ADDENDUM

NO. 1

PROJECT NAME: Early Learner's Academy 2

ADDENDUM DATE: June 19, 2025

1 ROOF FRAMING PLAN - AREA E
S6.05 1/8" = 1'-0"

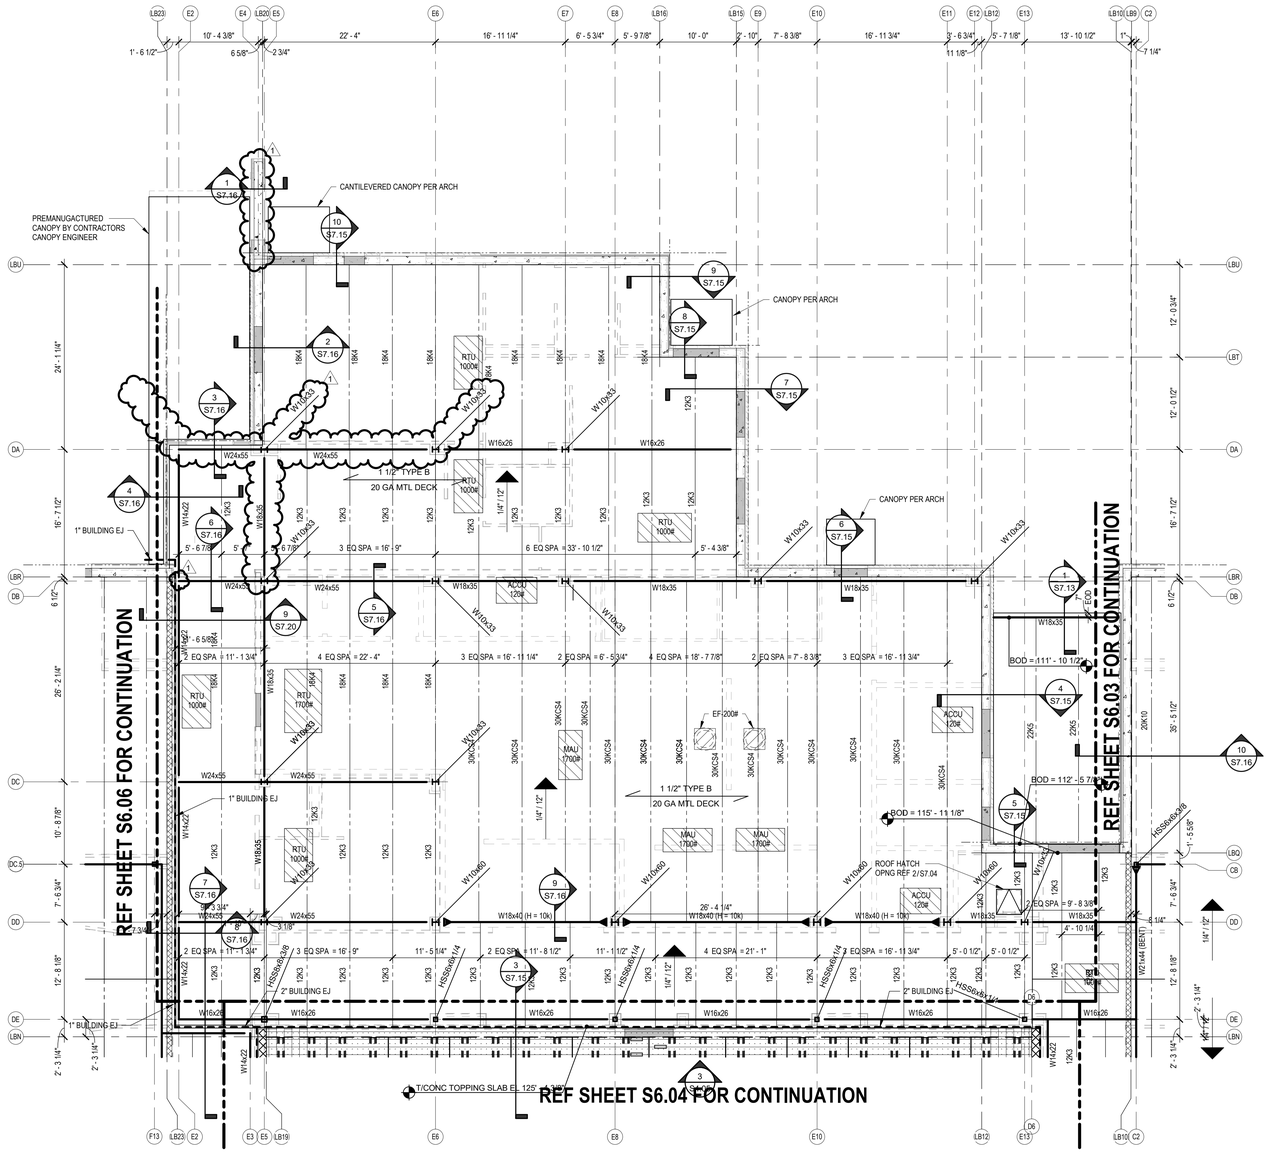
AD No 1, Struct Item 21: To the Drawings, Sheet S6.05, "ROOF FRAMING PLAN - AREA E"
Revisions and clarifications as follows:

1 ROOF FRAMING PLAN - AREA F
S6.06 1/8" = 1'-0"

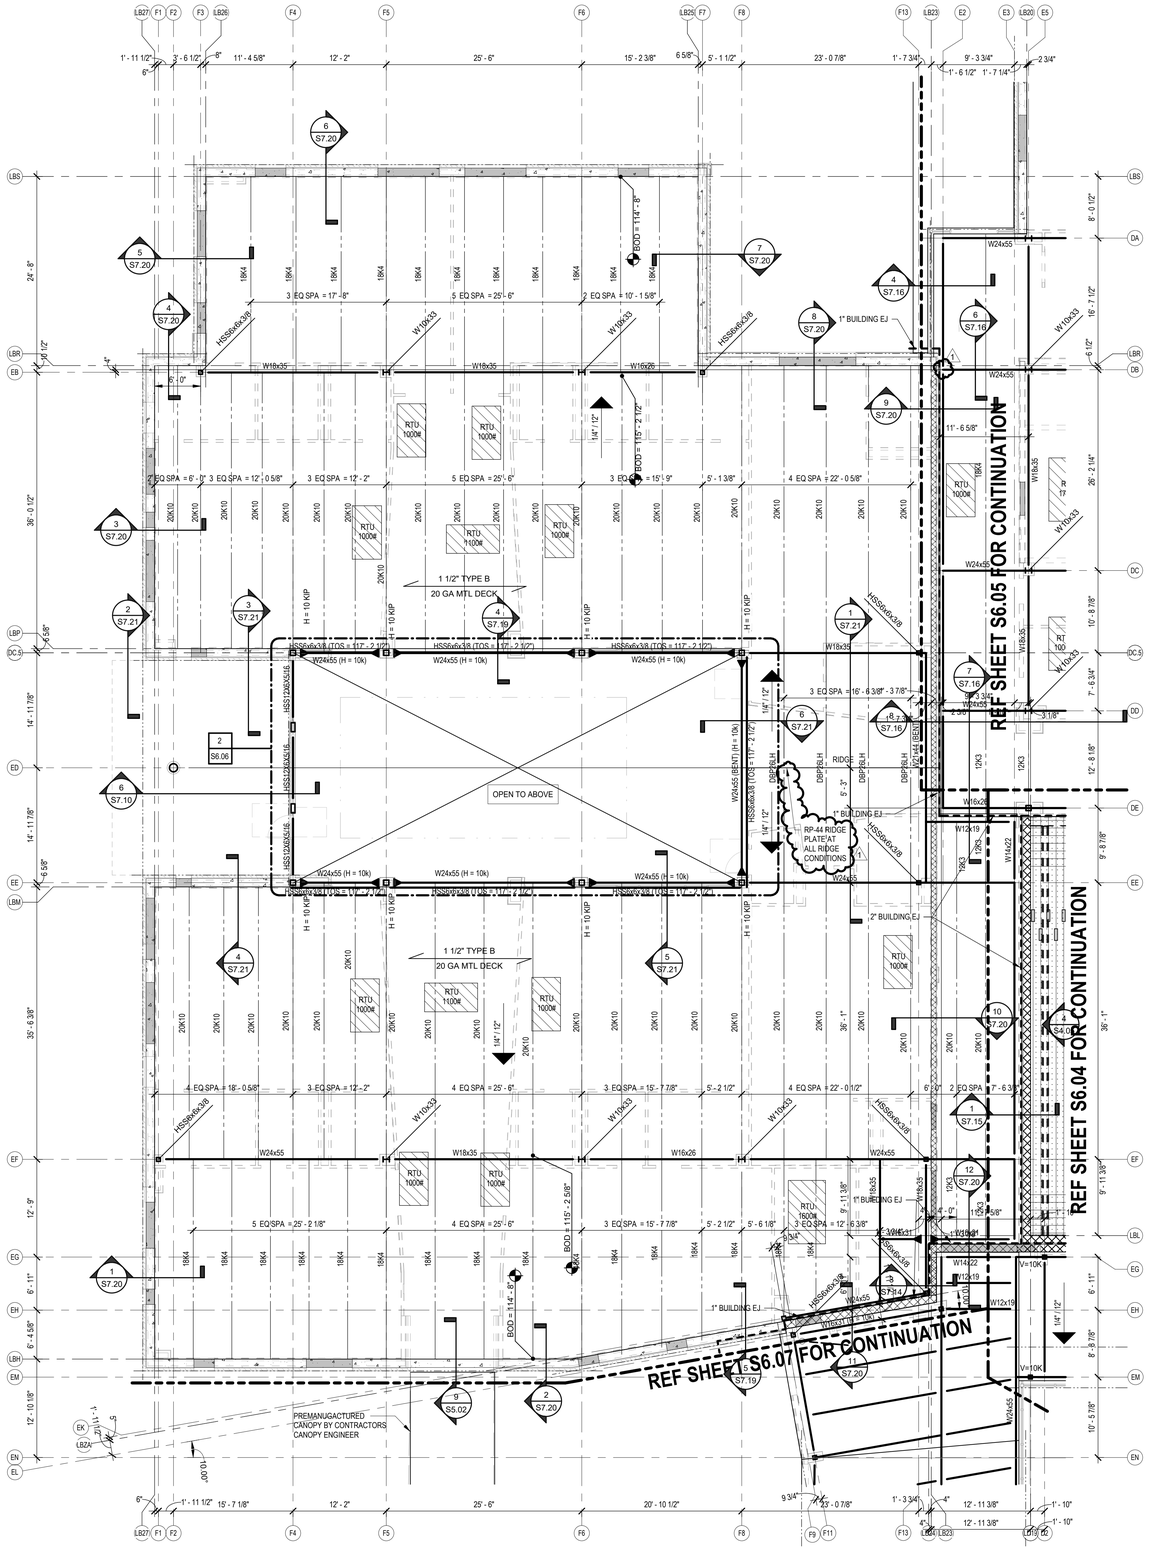
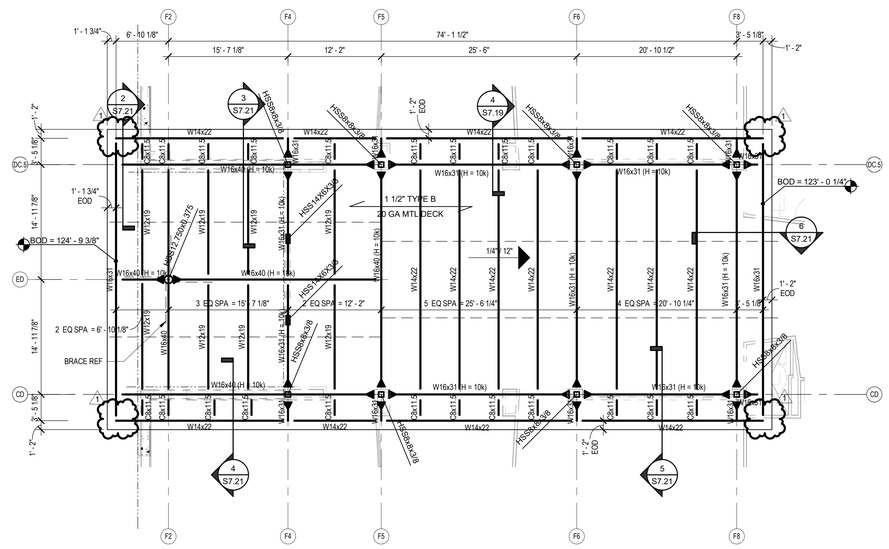
AD No 1, Struct Item 22: To the Drawings, Sheet S6.06, "ROOF FRAMING PLAN - AREA F"
Revisions and clarifications as follows:

6 SECTION
S7.10 1/2" = 1'-0" BACK REF: S6.01

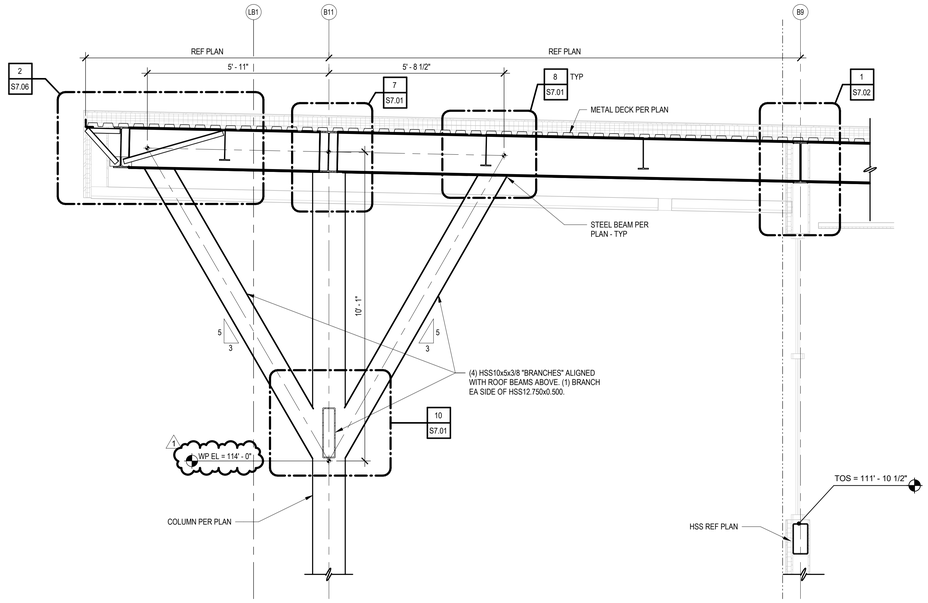
AD No 1, Struct Item 26: To the Drawings, Sheet S7.10, "FRAMING SECTIONS"
Revisions and clarifications as follows:

1) Elevation added to 6/S7.10.
2) Callouts added to 7/S7.10 and 9S7.10.

6 SECTION
S7.18 1/2" = 1'-0" BACK REF: S2.08

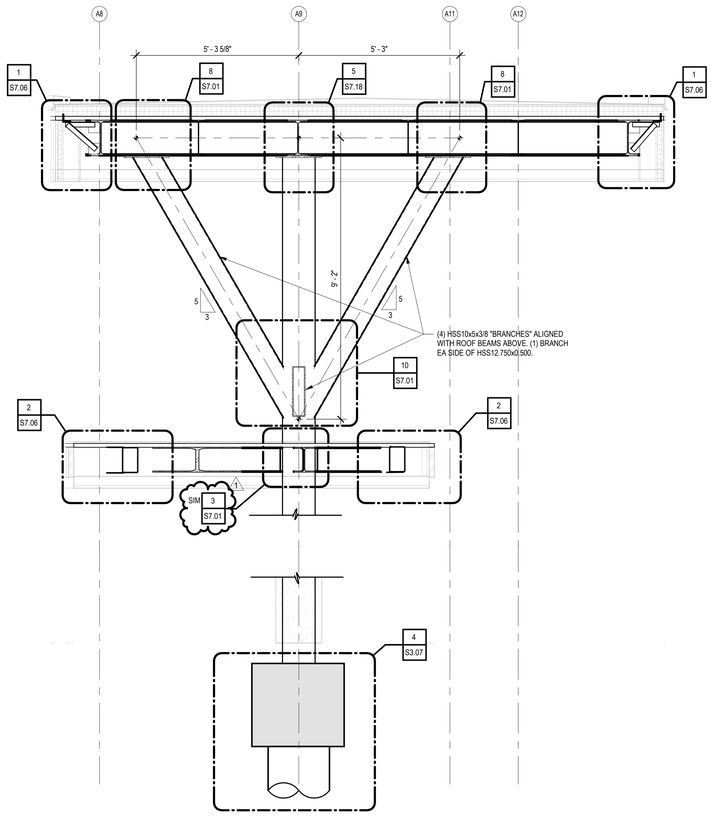
AD No 1, Struct Item 29: To the Drawings, Sheet S7.18, "FRAMING SECTIONS"
Revisions and clarifications as follows:

1) Text corrected in detail 3/S7.18 to remove reference to mid-height.
2) Callout added to 6/S7.18.

3 SECTION
S7.19 3/4" = 1'-0" BACK REF: S2.08

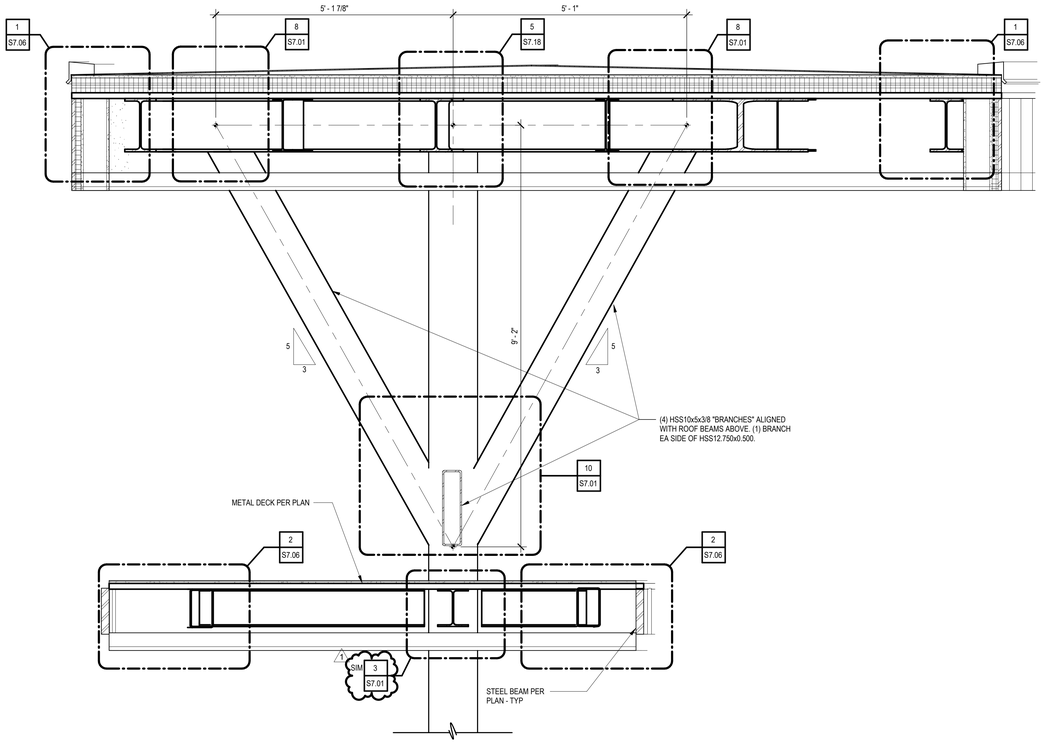
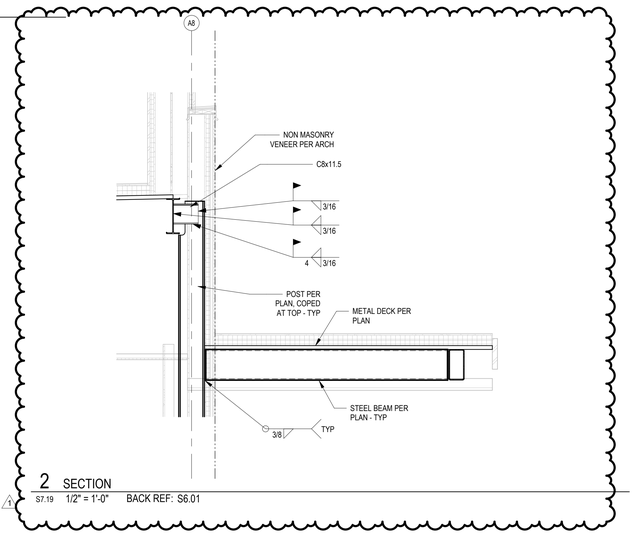
AD No 1, Struct Item 30: To the Drawings, Sheet S7.19, "FRAMING SECTIONS"
Revisions and clarifications as follows:

1) Callout added to 3/S7.19.
2) Detail 2/S7.19 expanded and additional information provided.

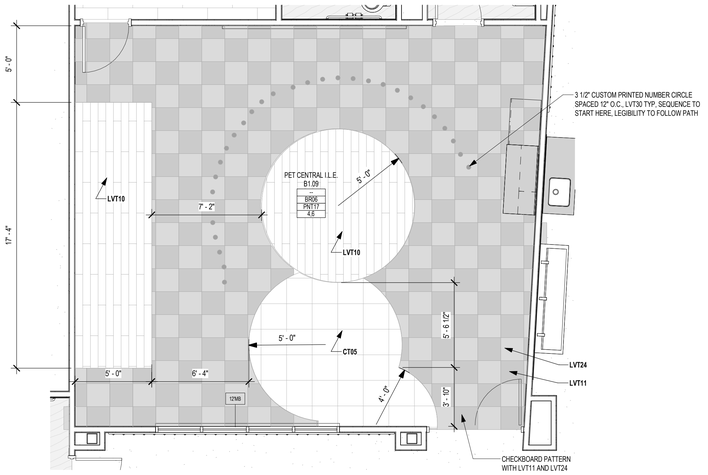
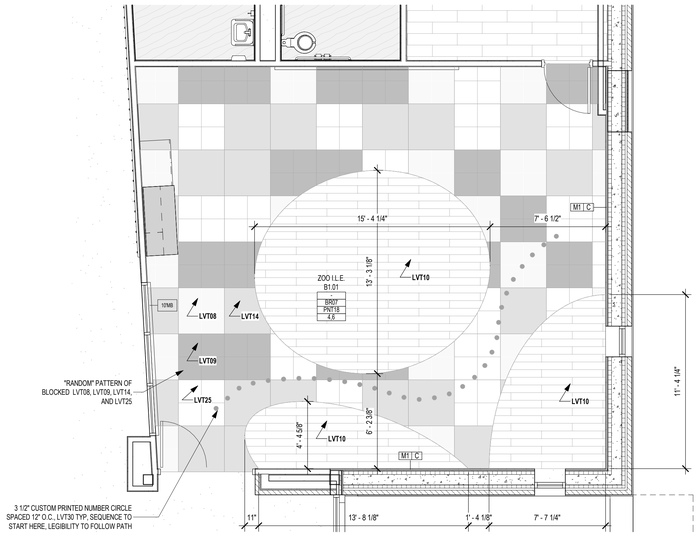
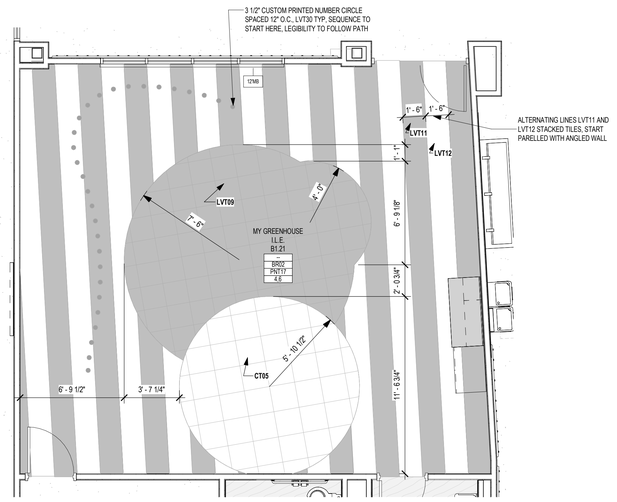
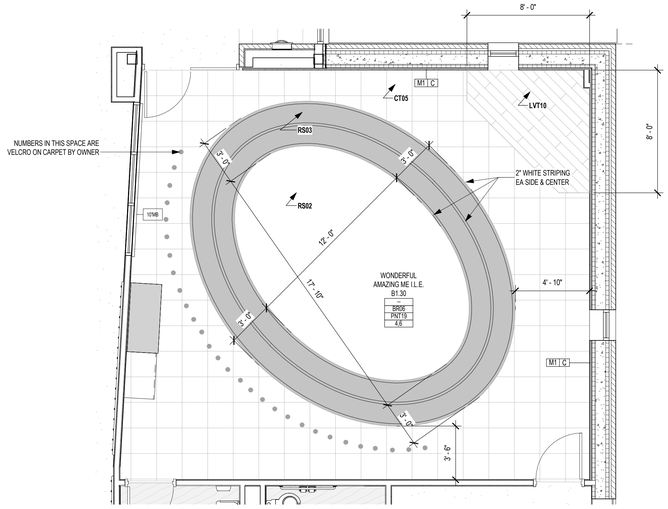
AD No 1, Arch. Item 11: To the Drawings, Sheet A4.13, "ENLARGED FINISH PLANS – EXPERIENCE CR – AREA B,"
Refer to attached drawings A4.13 for material and dimension updates.

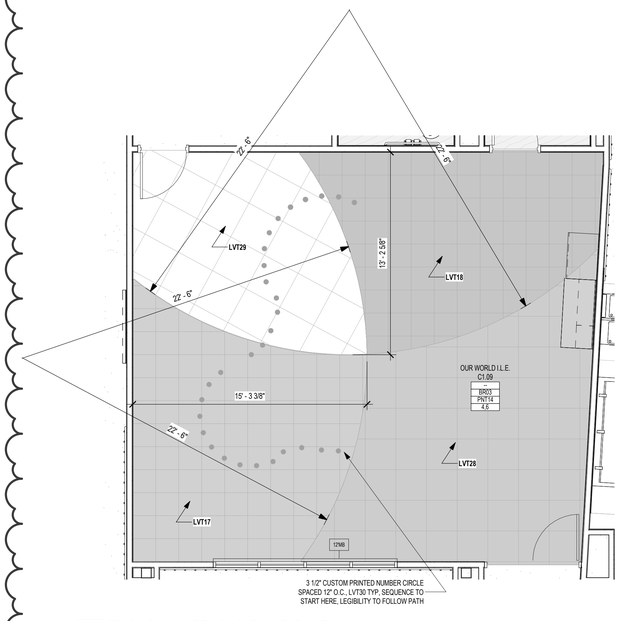
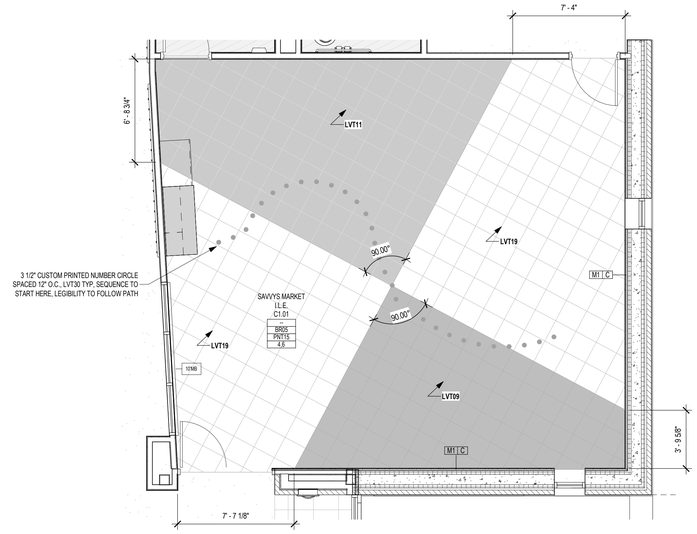
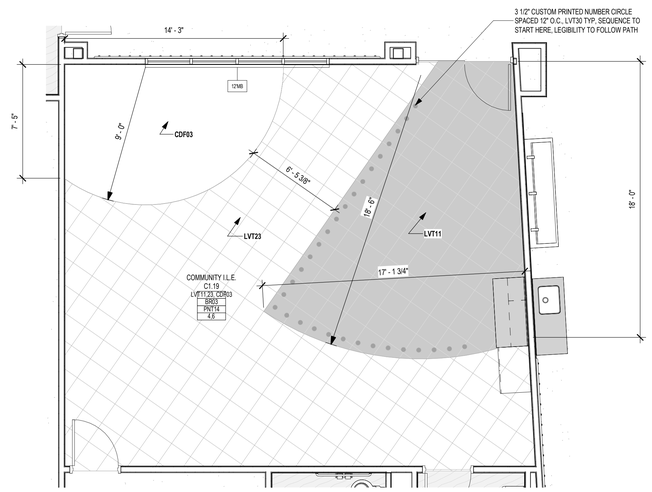
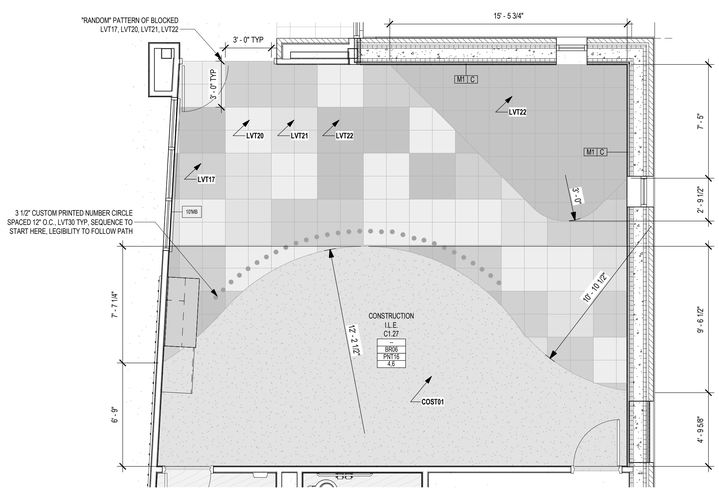
AD No 1, Arch. Item 12: To the Drawings, Sheet A4.14, "ENLARGED FINISH PLANS – EXPERIENCE CR – AREA C,"
Refer to attached drawings A4.14 for material and dimension updates.

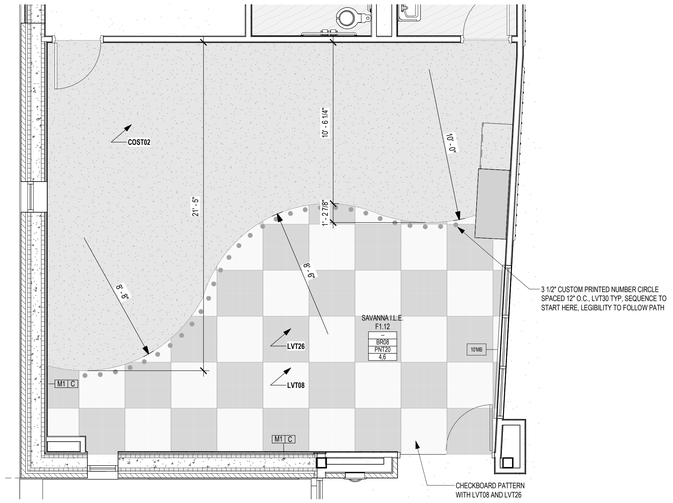
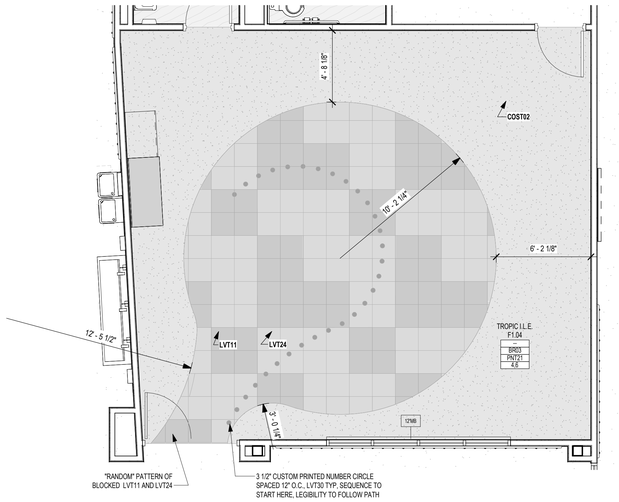
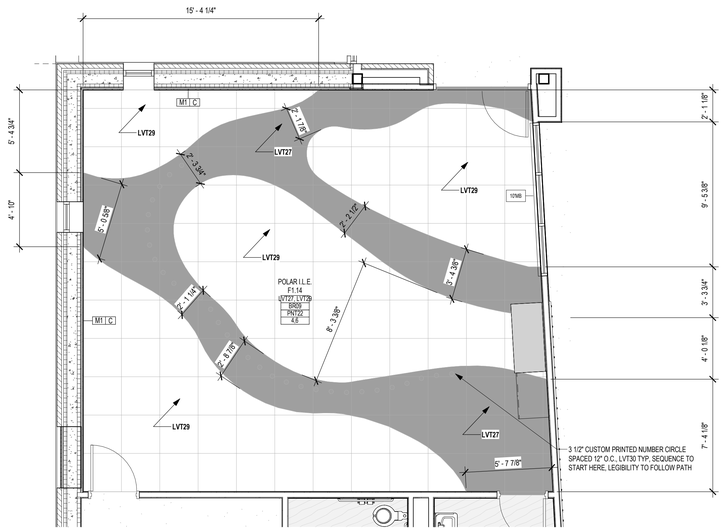
AD No 1, Arch. Item 13: To the Drawings, Sheet A4.15, "ENLARGED FINISH PLANS – EXPERIENCE CR – AREA F,"
Refer to attached drawings A4.15 for material and dimension updates.

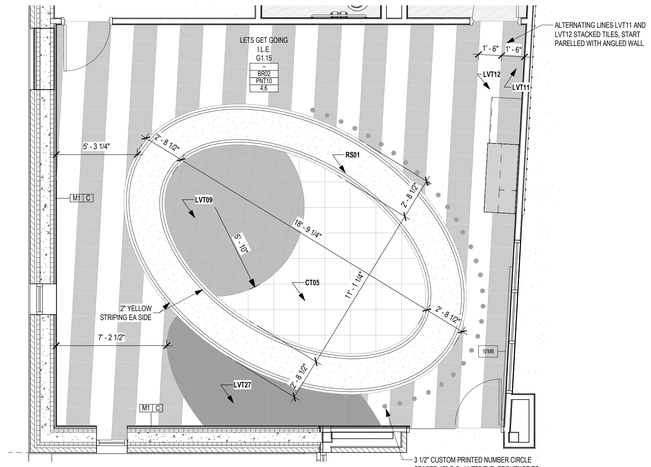
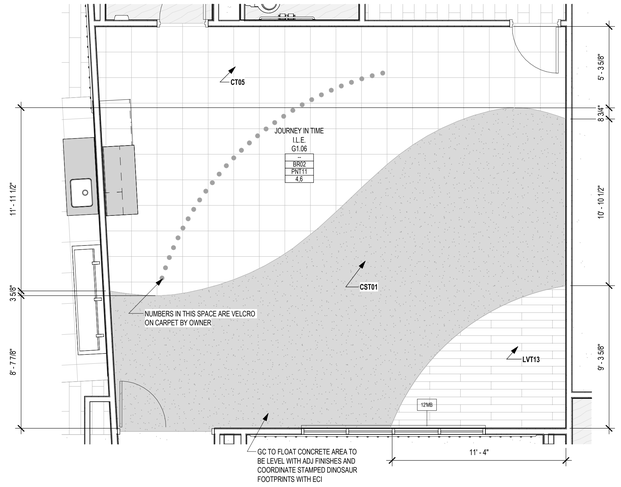
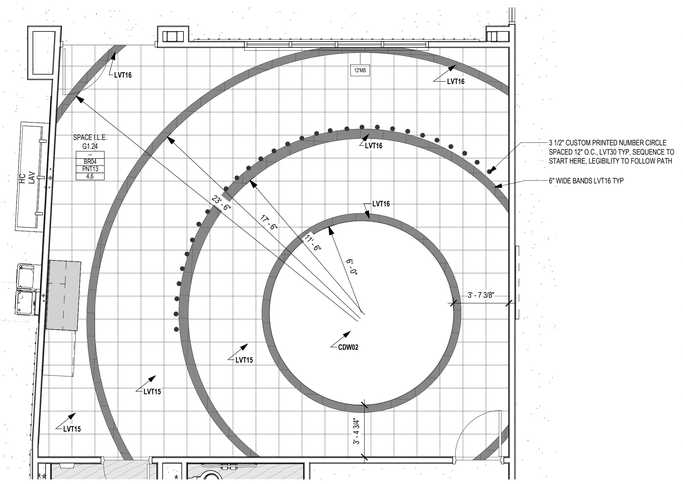
AD No 1, Arch. Item 14: To the Drawings, Sheet A4.16, "ENLARGED FINISH PLANS – EXPERIENCE CR – AREA G,"
Refer to attached drawings A4.16 for material and dimension updates.
